Project	IEEE 802.16 Broadband Wireless Access Working Group < http://ieee802.org/16 >	
Title	Corrections for the MS's Authorization Flow	
Data Submitted	2005-05-04	
Source(s)	Seokheon Cho Sungcheol Chang Chulsik Yoon, ETRI 161, Gajeong-dong, Yuseong-Gu, Daejeon, 305-350, Korea	Voice: +82-42-860-5524 Fax: +82-42-861-1966 chosh@etri.re.kr
Re:	IEEE P802.16e/D7	
Abstract	The existing PKMv2 is somewhat unorganized and insecure security framework. This contribution provides a resolution for unorganized and insecure MS's authorization flow in the PKMv2.	
Purpose	Adoption of proposed changes into P802.16e/D7	
Notice	This document has been prepared to assist IEEE 802.16. It is offered as a basis for discussion and is not binding on the contributing individual(s) or organization(s). The material in this document is subject to change in form and content after further study. The contributor(s) reserve(s) the right to add, amend or withdraw material contained herein.

Corrections for the MS's Authorization Flow

Seokheon Cho, Sungcheol Chang, and Chulsik Yoon
ETRI

0.1 IEEE P802.16e/D7 Status

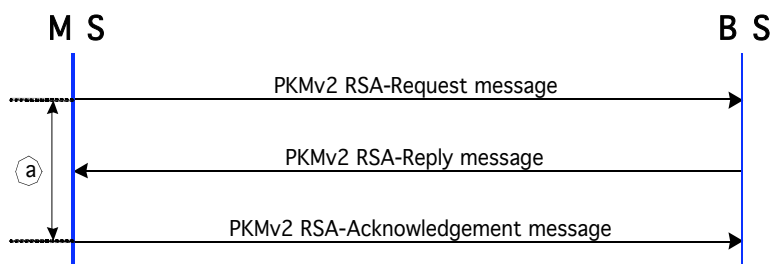
The AK is derived from the PAK or/and the PMK. The PAK and the PMK are obtained from the RSA-based Authorization procedure and the EAP-based Authorization procedure, respectively.

- For the RSA-based Authorization procedure:
 - The Authorization Request message and the Authorization Reply message in the RSA-based Authorization procedure are in the same rank as the EAP Transfer message in the EAP-based Authorization procedure. The Authorization Request/Reply messages contain Security-Capabilities, SAID, and SA-Descriptors, but the EAP Transfer message doesn't contain those parameters.

- The sequence number and lifetime included in the RSA-based Authorization procedure are not an AK sequence number and AK lifetime.
 - When the RSA-based Authorization procedure is selected, there is no message for informing the MS's authentication failure from BS to MS and the BS's authentication result (such as success or reject) from MS.

- For the EAP-based Authorization procedure:
 - The Key Sequence Number used in the Authenticated EAP-Transfer message is not an AK Sequence Number.
 - The BS doesn't know the completion time of the EAP-based Authorization procedure in case that EAP protocol doesn't yield AAA-key and whether an MS receives the last EAP Transfer message (such as "EAP Success" used in EAP-TLS) or not. Both the BS and the MS cannot simultaneously share the AK derived from PMK, when an MS doesn't receive the last EAP Transfer message.

- AK generation process needs more secure mechanism.

b) For the EAP-based Authorization procedure:

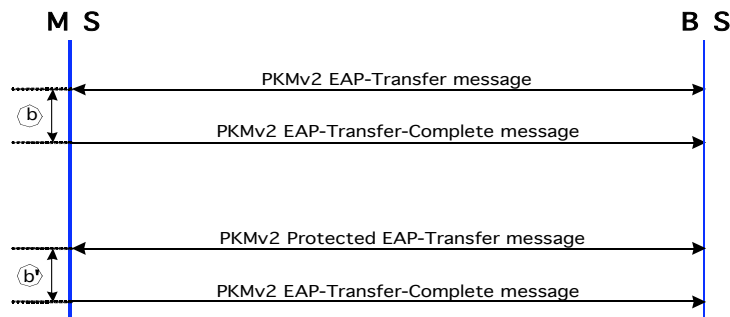
- The messages used in the EAP-based Authorization procedure are as follows
- The Key Sequence Number used in the PKMv2 Authenticated EAP-Transfer message is not an AK sequence number but PAK sequence number.
- In order that BS knows the completeness time of EAP-based Authorization procedure in case that EAP protocol doesn't yield AAA-key and whether a MS receives the last EAP Transfer message (such as "EAP Success" used in EAP-TLS) or not, an MS shall send the PKMv2 EAP-Transfer-Complete message to report EAP-based Authorization completeness. Therefore, both MS and BS can synchronize the AK.

- i. PKMv2 EAP-Transfer message: EAP Payload
- ii. PKMv2 Authenticated EAP-Transfer message: Key Sequence Number (PAK), EAP Payload, OMAC Digest (from EIK)
- iii. PKMv2 EAP-Transfer-Complete message:

c) For MS's Authorization Key Generation procedure:

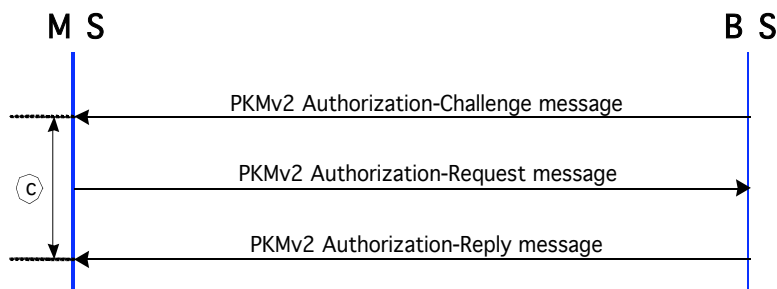
- To assure more secure AK, seeds (such as MS_Nonce and BS_Nonce) should be used to derive AK.
- To protect from replay-attack, the messages needed in MS's AK Generation procedure should contains random number (such as MS_Nonce and BS_Nonce) and message authentication function (such as OMAC Digest).
- The messages with important parameters, e.g. Security-Capabilities, SAID, and SA-Descriptors, should be authenticated.
- This procedure supports secure 3 way handshake.

- i. PKMv2 Authorization-Challenge message: BS_Nonce
- ii. PKMv2 Authorization-Request message: Key Sequence Number (PAK), MS_Nonce, BS_Nonce, Security_Capabilities, SAID, OMAC Digest (from AK)
- iii. PKMv2 Authorization-Reply message: Key Sequence Number (AK), Key Lifetime (AK), BS_Nonce, (one or more) SA-Descriptor(s), OMAC Digest (from AK)
- iv. PKMv2 Authorization-Reject message: Error-Code, Display-String, BS_Nonce, OMAC Digest (from AK)
